**2021/1239**

*Erection of two storey side extension and construction of boundary retaining wall on Rochester Road frontage*

*23 Rochester Road, Monk Bretton, Barnsley, S71 2NJ*

PROPOSED FRONT

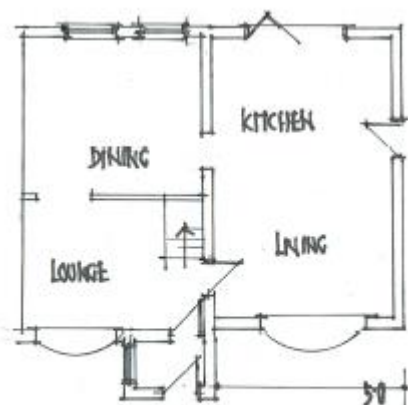
However, the SPD states '*the sideways projection of a two-storey side extension should not exceed more than two thirds the width of the original dwelling*'. The proposed extension is more than double the width of the existing front elevation, as such, is contrary to the requirements of the SPD.

The width of the extension results in an addition which is not subordinate to the host property and unbalances the front elevation as such it would not be of a scale and design which harmonises with the existing building, again contrary to the SPD and Local Plan policy D1. Furthermore, the rear corner of the extension would immediately adjoin the side elevation of the existing detached garage which would result in an awkward arrangement.

In term of the design and appearance of the extension, it takes very few design cues from the host dwelling. The front elevation of the host property is very distinctive in terms of the material palette in that the materials at ground and first floor differ, however, this has not been carried over into the extension. The extension has large areas of blank brick work evident and is very plain, especially on the side elevation which would be highly visible.

In addition, the proposed openings and fenestration in the extension do not reflect the dimensions within the host property. The proposed windows, especially on the front elevation are wider and do not harmonise with the existing, to the detriment of visual amenity and contrary to Local Plan Policy D1.
